**W.E. Dentmon Construction, Inc.**

**ROOMS TO GO – Cutler Bay, FL**

**PREBID REQUEST FOR INFORMATION # 1**

**7** SOFFIT DETAIL  
A6.5 SCALE: 1 1/2" = 1'-0"

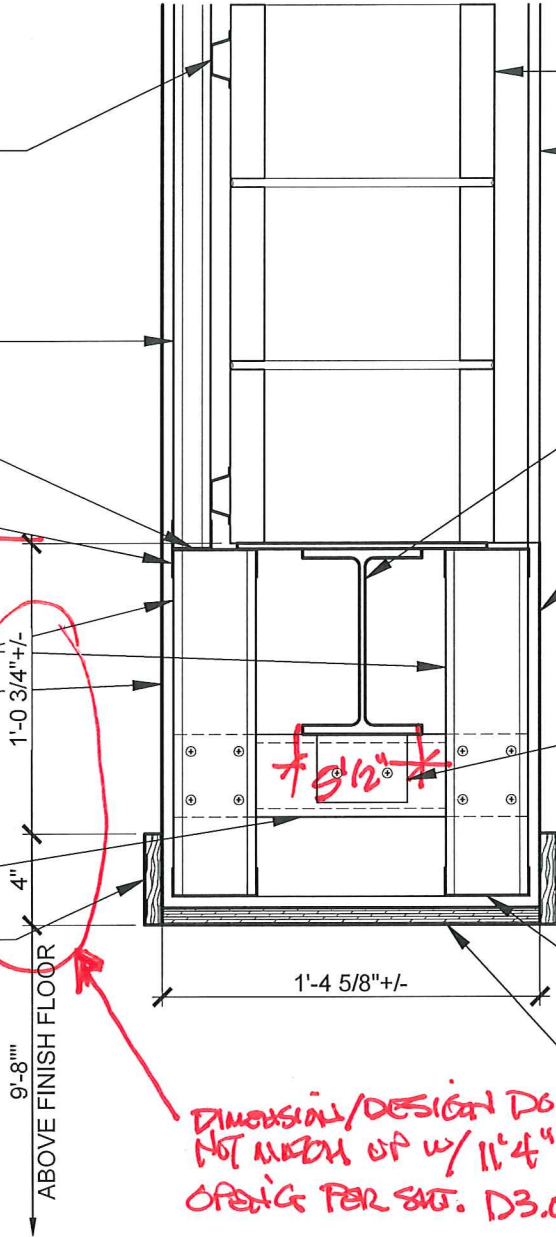
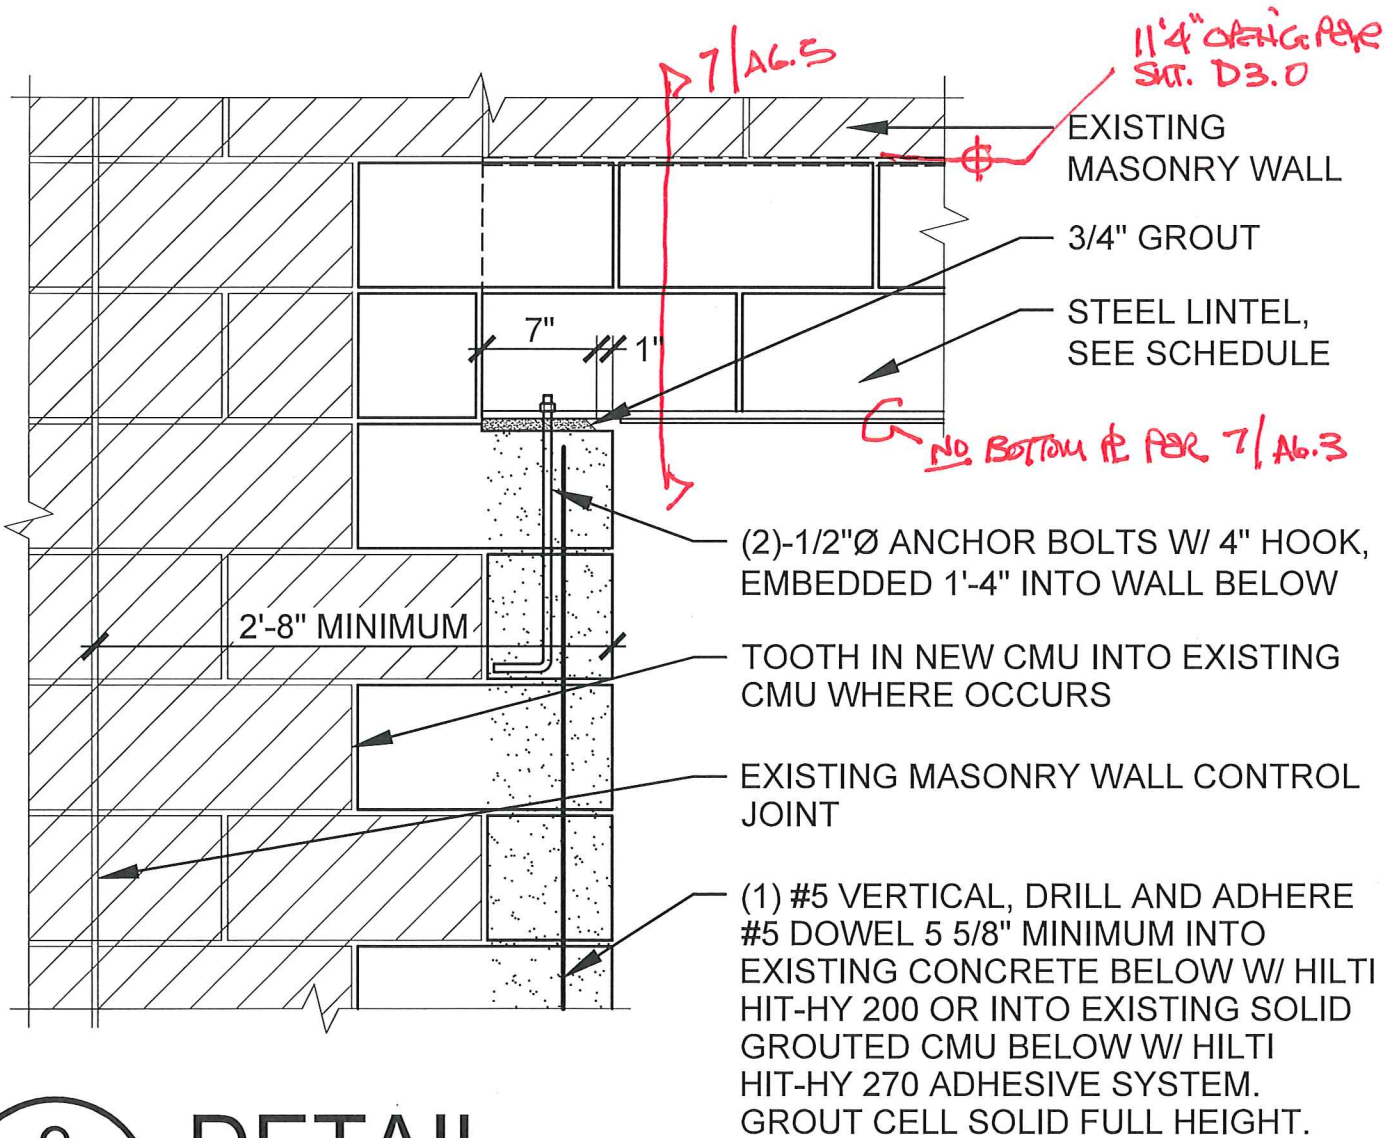
<b>Request Description:</b>
Confirm that the steel lintel (W16 x 26 with 11" top plate) at both new openings in the existing exterior masonry wall does not need to be encased in masonry as implied per 9/S2.0. If these lintels require masonry, provide a support detail since the bottom flange of W16 is only 5 1/2" wide. Also verify the height of the masonry opening at 11'-4" AFF since 7/A6.5 seems to imply something different.

<b>REPLY:</b>
The steel lintels do not have to be encased in masonry like 9/S2.0. The new openings between the existing building and the new addition are to be encased with metal studs and gyp. board like 7/A6.5.  The masonry opening is at least 11'-4" a.f.f. The finished opening is 9'-9" per 7/A6.5

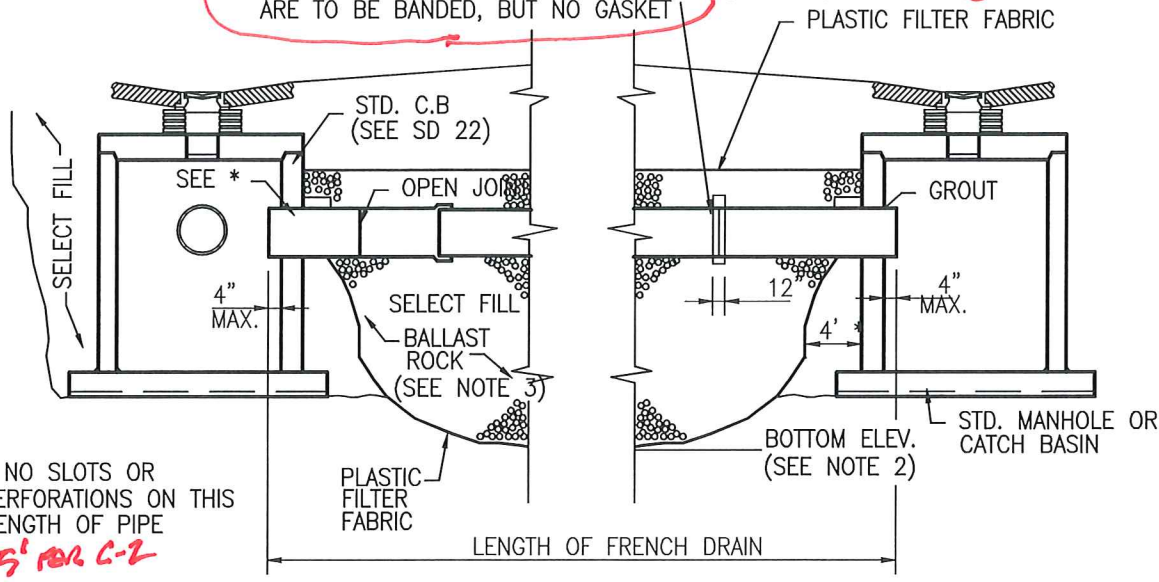
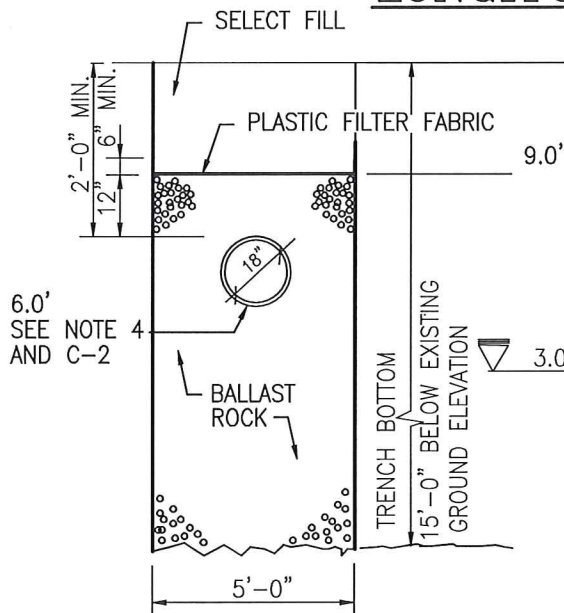
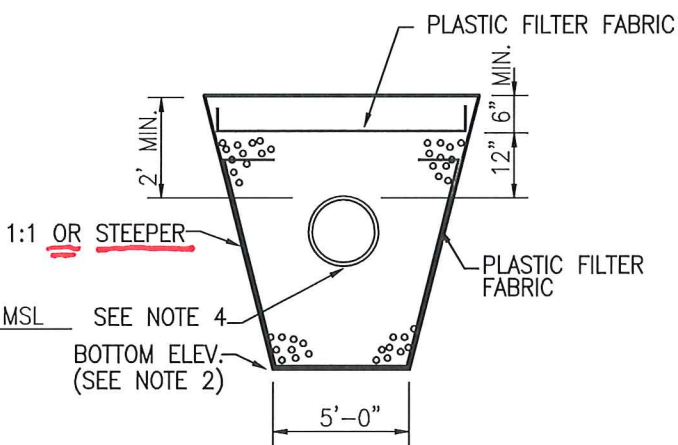
<b>Request Description:</b> Provide clarification for the exfiltration trench storm drainage pipe since Sheet C-5 shows “perforated CMP, pipe joints are to be banded” whereas Sheet C-2 specifies slotted RCP.
--

**17 DISABLED PARKING SIGN STANDARD (PER MIAMI-DADE COUNTY R-18.3)**  
NOT TO SCALE

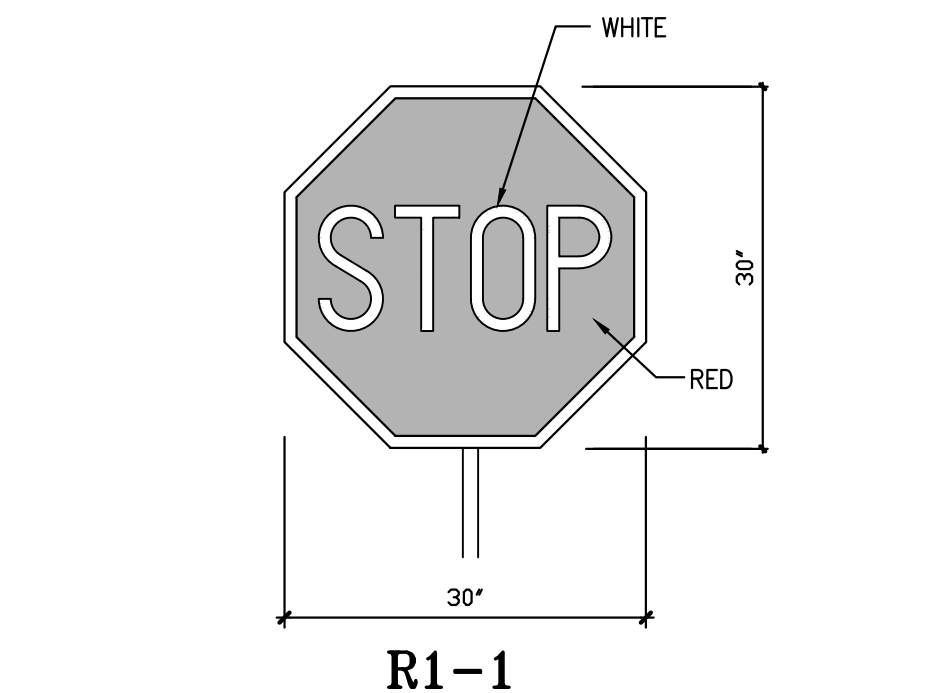
<b>Request Description:</b> Provide clarification for the type and size for both the stop signs and handicap parking signs, since there are different requirements shown on Sheets C-1.2 (Note 18), C-4 (Detail 17 & 18) & C-7 (Detail 6 & 7).
---

<b>REPLY:</b>  <b>Stop Sign to be 30" x 30". Disregard note 18 on C-1. The handicap parking sign should read as shown on C-4 detail 17.</b>
---

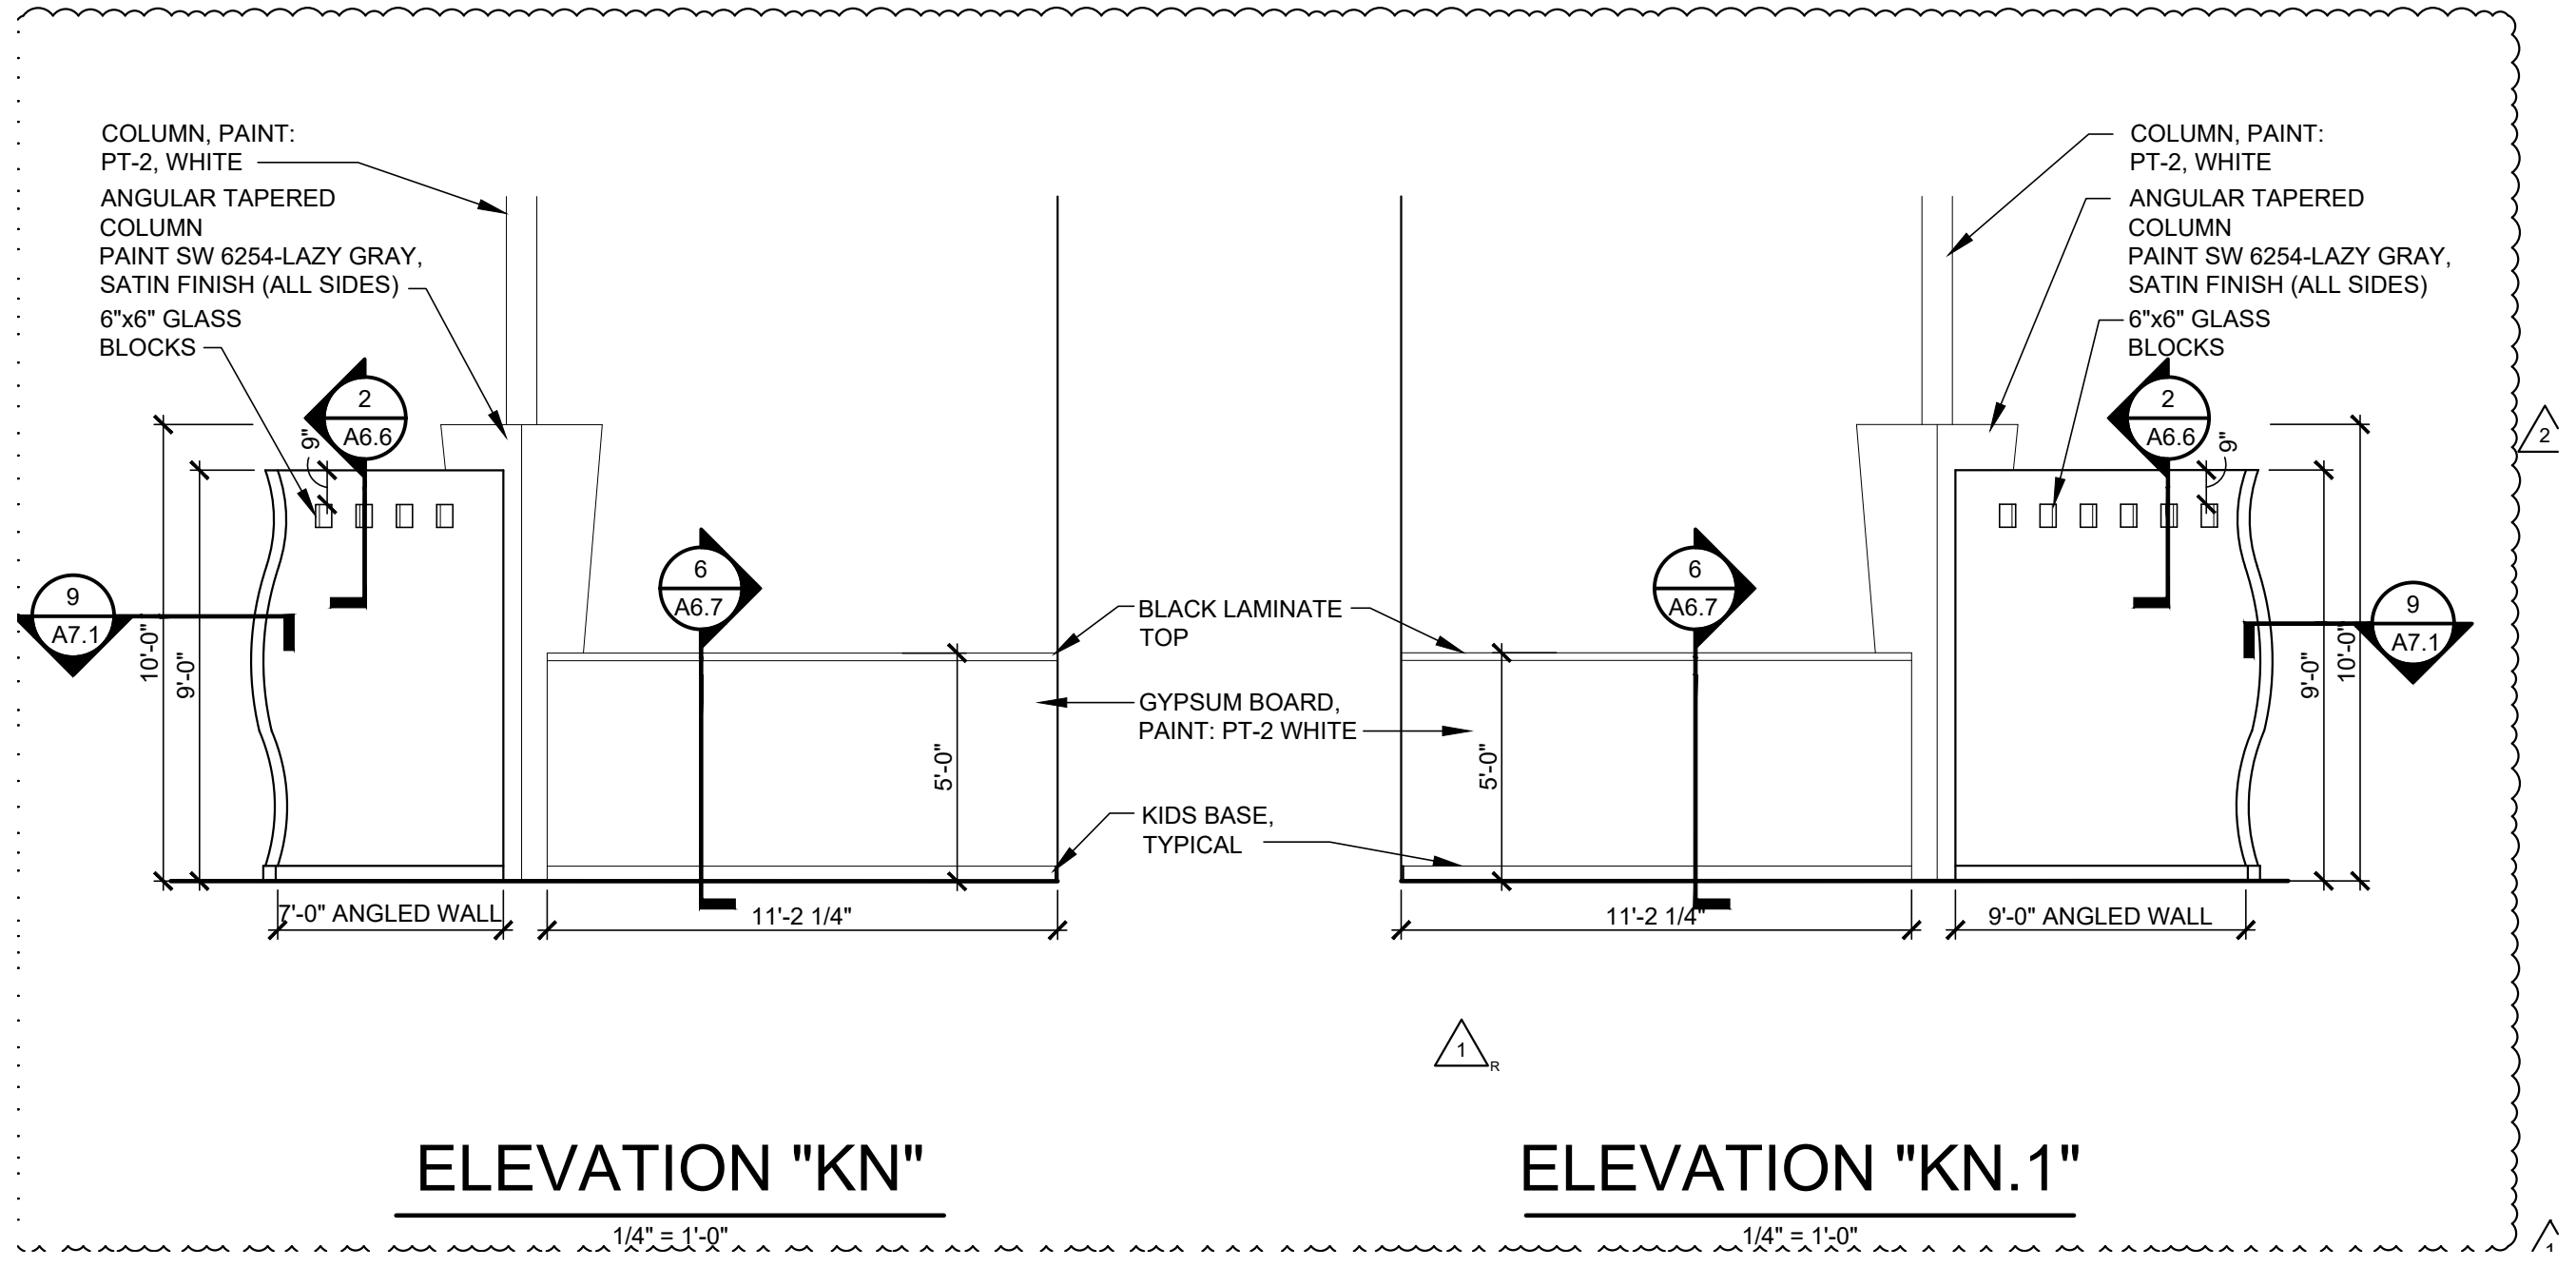
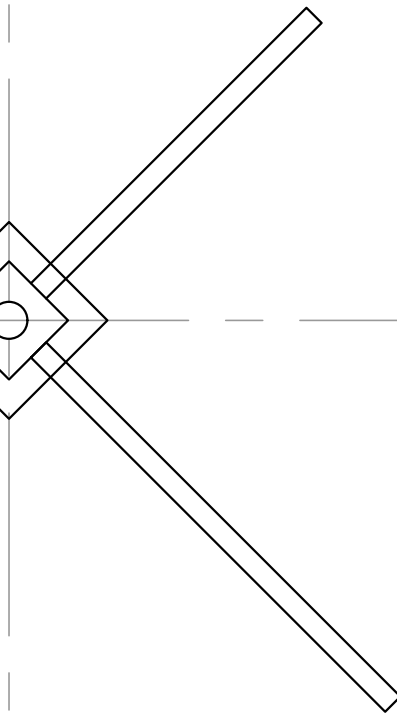
<b>Request Description:</b> Provide elevations/details for both angled partitions off of Column E/2 in the Kids area since none is shown on Sheet A1.2.

**MECHANICAL PLAN**  
**M2.0**

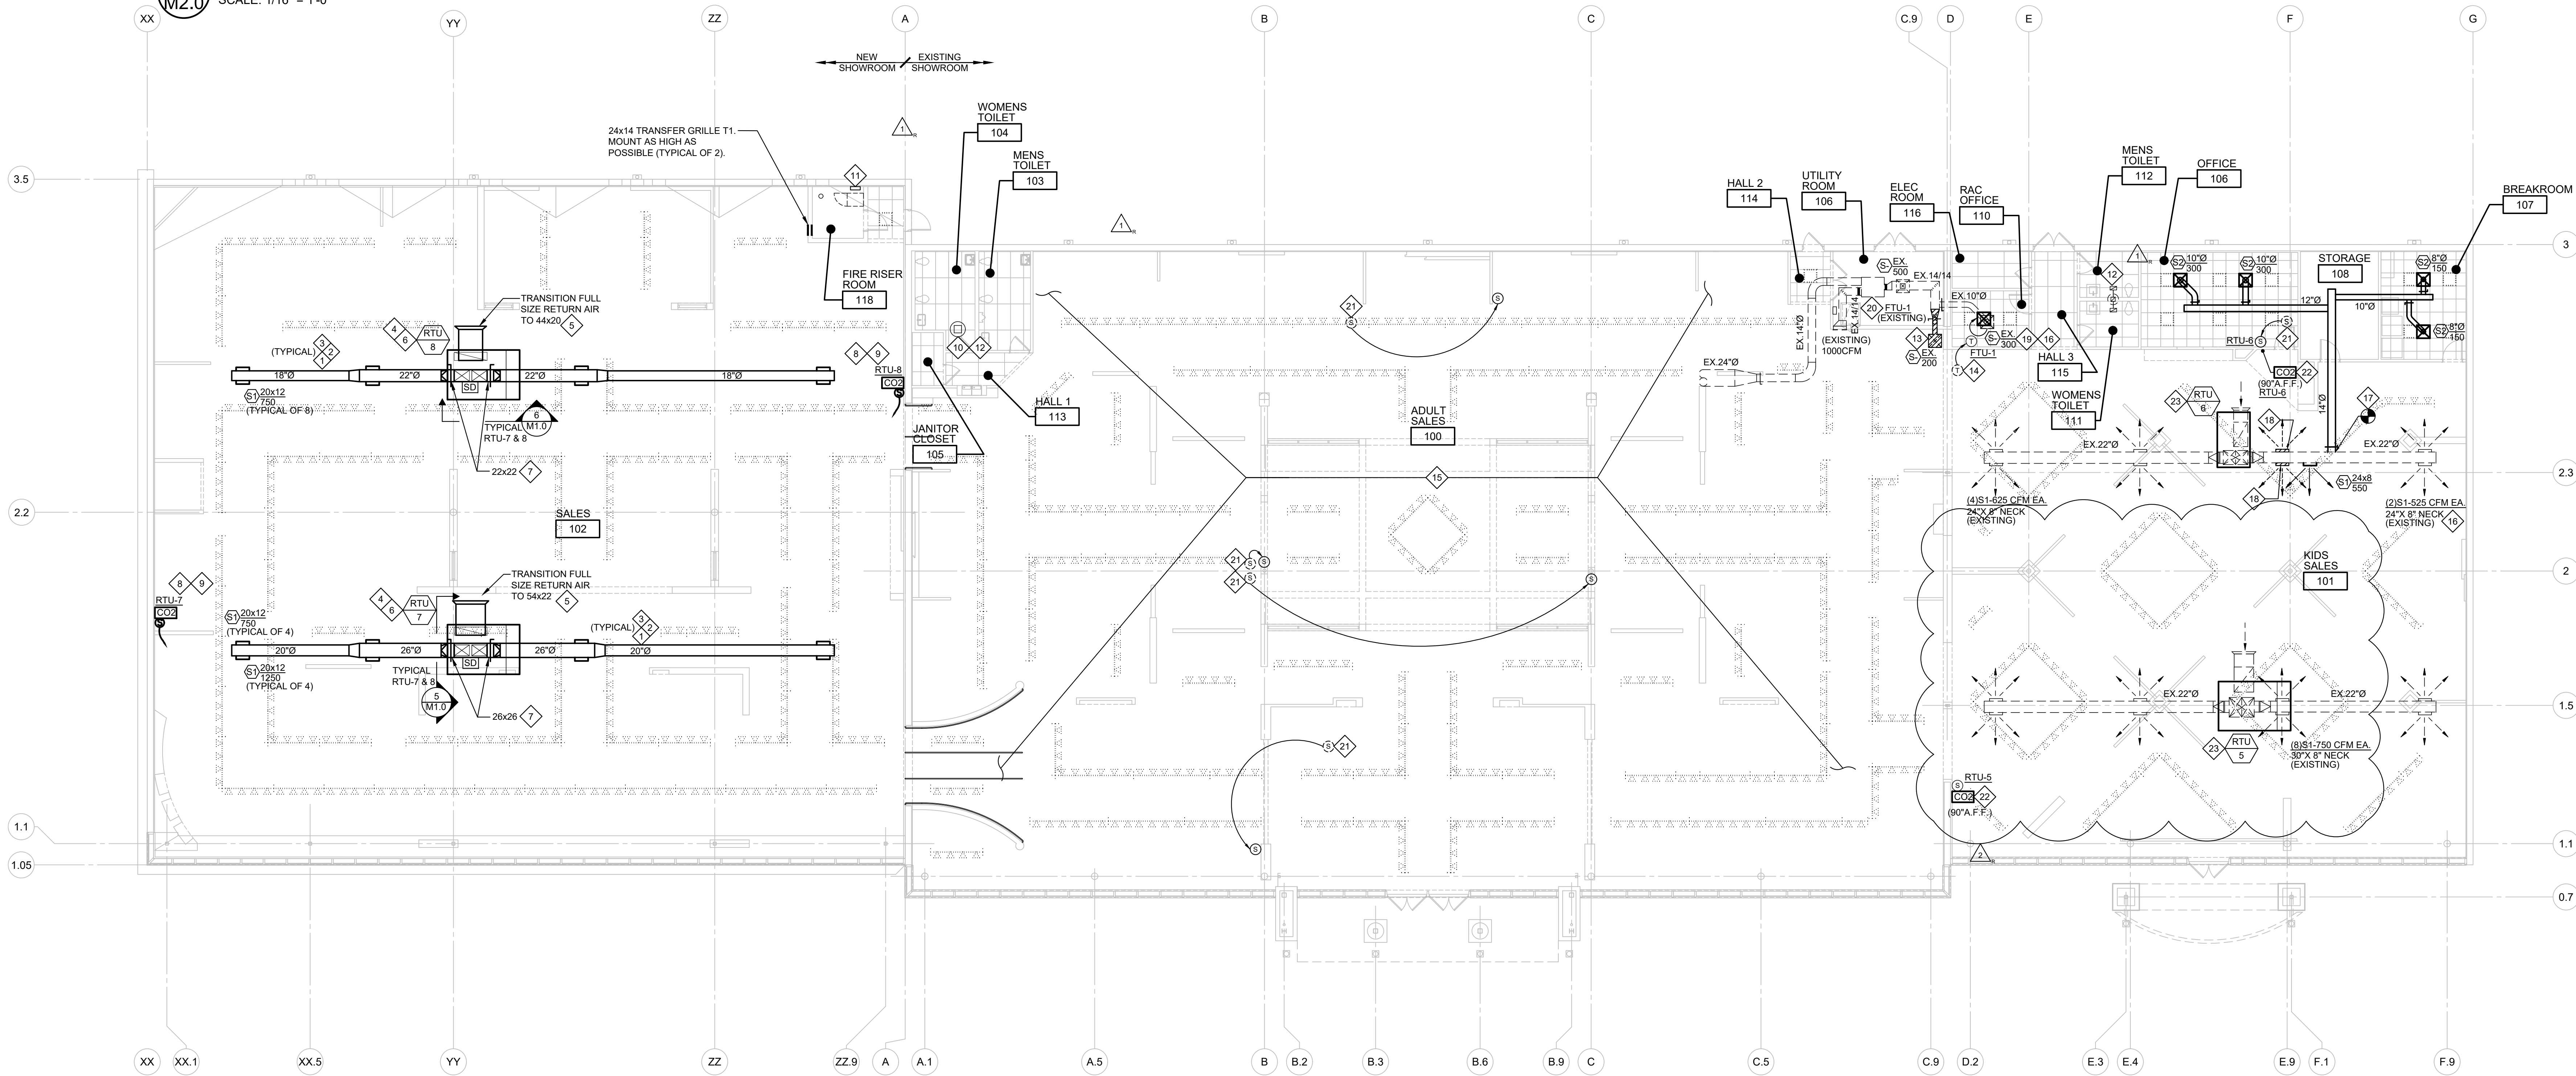
<b>Request Description:</b> Provide guidance as to the added CO2 sensors in the renovated Kids Area since Sheet M2.0 identifies two (2) separate sensors for RTU #6 and none for RTU #7. Also, one of the sensors is shown in the middle of the floor space where there is no partition.

<b>REPLY:</b>  <i>The two new rooftop units serving the renovated Kids Area are RTU-5 and RTU-6. Each RTU should have one new CO2 sensor. Provide the RTU-5 CO2 sensor on the full height wall near the existing RTU-5 temperature sensor or on a nearby full height partition wall. The CO2 sensors must be mounted on a full height wall. See attached revised sheet M2.0 to be issued in a future issuance.</i>
--
